#### **RE: Fire Comments**

# Monday, April 21, 2025 Hall County Planning Commission Meeting

1. (A) 2905 McEver Road | Special use | to amend conditions of zoning in GCOD | on a 1.00± acre tract located on the south side of McEver Road approximately 826 feet from its intersection with Green Road |

Zoned H-B; Tax Parcel 07300 000003A | Proposed Use: Expansion of vehicle sales and vehicle repair, major | \*\* Commission District 2 | Fady Hanna, applicant

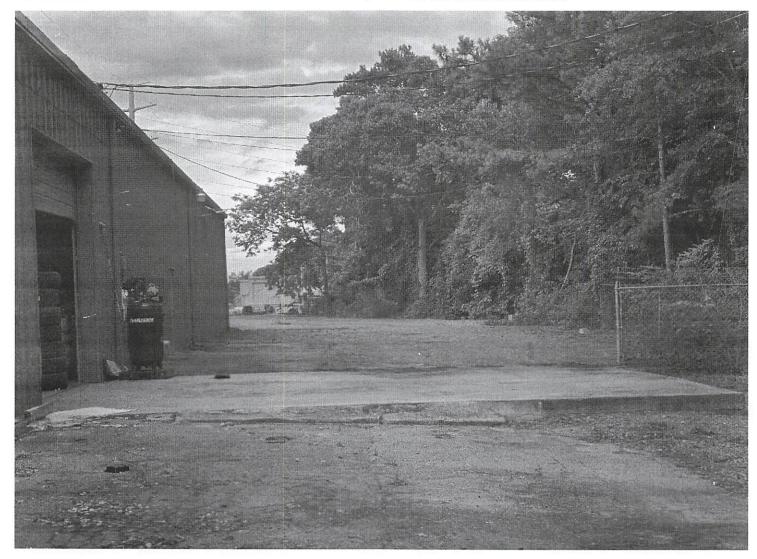
- 1. Parcel Tag Attached to 2905 McEver Road.
- 2. Outstanding Fire Code Violations that have not been corrected as of 3/19/25
- 3. The Hall County Fire Marshal's Office has received numerous citizen complaints regarding traffic safety concerns of cars parked along the shoulder of the road in front of the business, see attached overview that shows 6 cars parked on the shoulder of the north bound lane of McEver road.

- 4. International Fire Code 503.4 Obstruction of fire apparatus access roads. Fire apparatus access roads shall not be obstructed in any manner, including the parking of vehicles. The owner consistently blocks fire apparatus access to the building with vehicles.

- 5. The owner is approved for 15 cars, as you can see from the attached overview the inventory of vehicles for sale and vehicles awaiting repair exceed 15.

Thank you for speaking with me the other day regarding the fire comments for your business located at 2905 McEver Rd. As we discussed, John Hornick's comments (listed below) were based on previous fire inspections and citizen complaints regarding too many vehicles on the premises. You provided photos showing a large number of vehicles have been removed and you stated you are currently within county regulation for the number of vehicles permitted on the property. The outstanding fire inspection violations have been corrected since the below email was sent. Being that you are the new owner of the business and the occupancy classification has not changed from the previous owner, it has been determined that the current parking configuration of the parking lot will suffice. You have resolved the fire comments so I currently have no issues with your business. As a reminder, vehicle access to and around your building must remain clear to allow fire and EMS apparatus to respond without obstruction.
